Subject: FW: County of Peterborough - 15CD-18001

RE: Application for Plan of Condominium and Revised Plan of Subdivision Granite Ridge (Phase 2)

Re: Revised Plan of Subdivision & Plan of Condominium

File No.: 15T-12003 & 15CD-18001

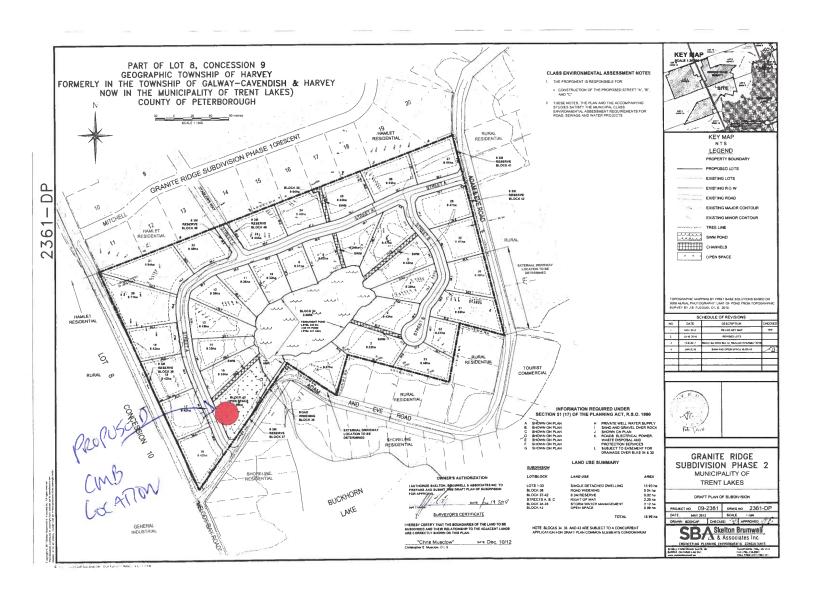
- 1. Canada Post will provide mail delivery service to the development through centralized Community Mail Boxes (CMBs).
- 2. Given the number and the layout of the lots in the development.
- 3. The development will be served by CMB, at the side of Block 43 facing street A (attached).
- 4. If the development includes plans for (a) multi-unit building(s) with a common indoor entrance, the developer must supply, install and maintain the mail delivery equipment within these buildings to Canada Post's specifications.
